DATE: 10-25-16

COUNCIL ACTION FORM

REQUEST: **PRELIMINARY PLAT FOR 2617 BOBCAT DRIVE (RINGGENBERG PARK SUBDIVISION, 5TH ADDITION)**

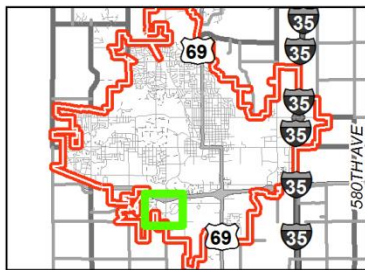
As discussed above, the Bobcat Drive exceeds block requirements of the Subdivision Code. Additionally, the configuration of the Bobcat apartments does not fully meet the Zoning Ordinance standard for through walkways when a block exceeds 660 feet. The intent of the zoning requirement for this site would be to have a connection north south through the site from Oakwood to Suncrest. The walkway to Oakwood does exist to the west of this site and the developer will connect to it. However, a walkway to the south was not constructed with the apartments. The 2013 Master Plan and 2014 Major Site Development Plans had a walkway that connected the parking lots to the entrances of the apartments and to Suncrest for Lots 6,7,8. There was no internal connection directly to the Oakwood walkway. The Suncrest walkway was not installed with the final improvements and walkways were only constructed that connected the building entrances to Suncrest.

Staff believes the intent of the zoning standard has not been fully accomplished for the site due to the lack of connectivity throughout the site north to south. Although a Suncrest connection is off-site from the subject site, completing a walkway connection through Lots 6 and 7 to Suncrest would be the most logical location due to the grades of the area and the alignment of the walkway with a trail connection that exists in the Ringgenberg Park subdivision to the south. This connection would provide trail access to the primary open space located ¼ of a mile to the south that is meant to meet the

needs of this site. This sidewalk would connect through a small parking lot to Bobcat and then to the new sidewalk constructed by the applicant with the single-family attached homes. A condition is included as part of Alternative 1 to provide the additional walkway to Suncrest.

- D. Prior to final plat approval, a five-foot private sidewalk from Bobcat to Suncrest Drive between lots 6 and 7 of the 4th Addition shall be completed or financially secured with written acknowledgement of the property owner(s) to authorize its installation.
